## **C5.4 Pretensioned Prestressed Concrete Beam**

**Methods Memo No. 77: Changes to new BTC and BTB Beams (Supersedes Methods Memo No. 66 in cases of conflict)**  
**14 January 2003**

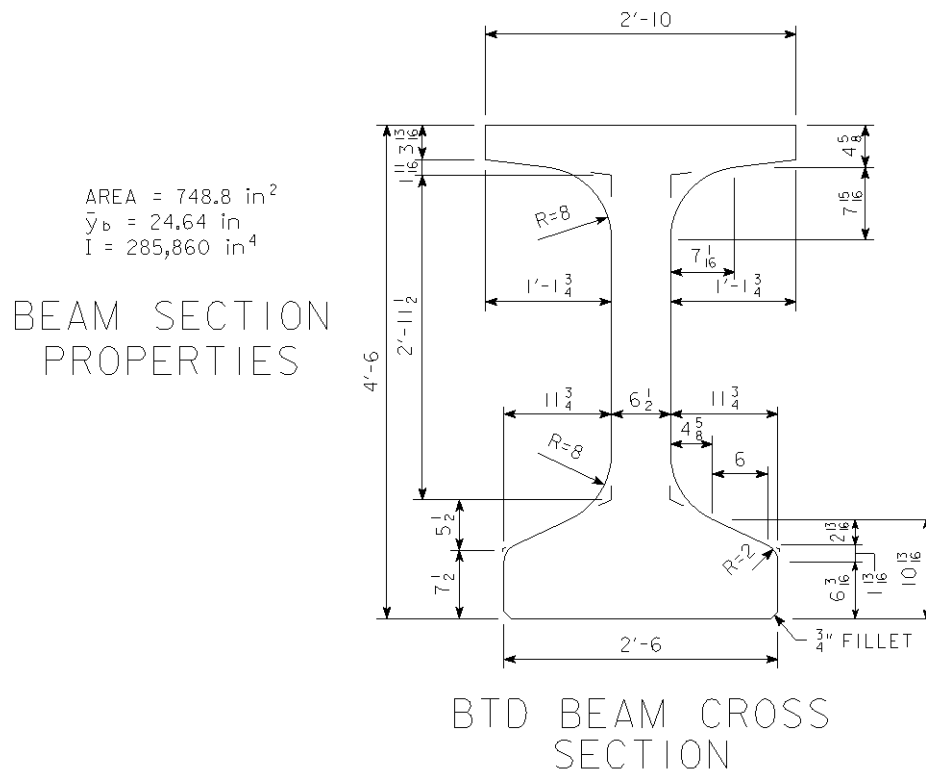
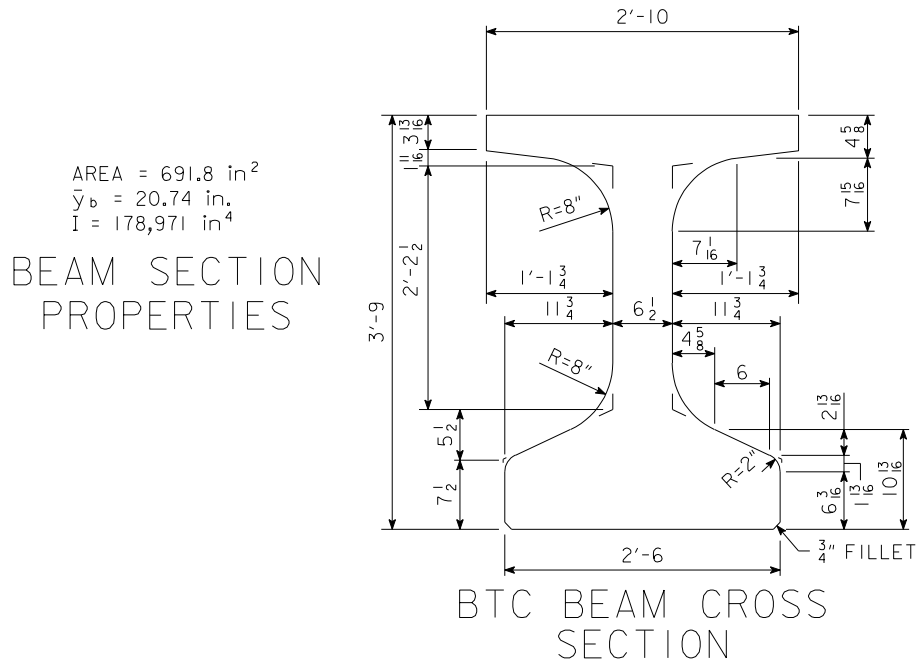
1. Top flange width:

To reduce beam weight the width of the top flange was reduced from 48 inches to 34 inches. See attached sheet showing modified sections.

2. Top flange edge bars (5c1 and 5c4):

Because of changes in the AASHTO LRFD specifications and the use of the narrower flange width, the top flange edge bars (5c1 and 5c4) were eliminated.

3. Block out Detail:

The block out detail was eliminated and the flange width will be constant along the entire length of the beam.
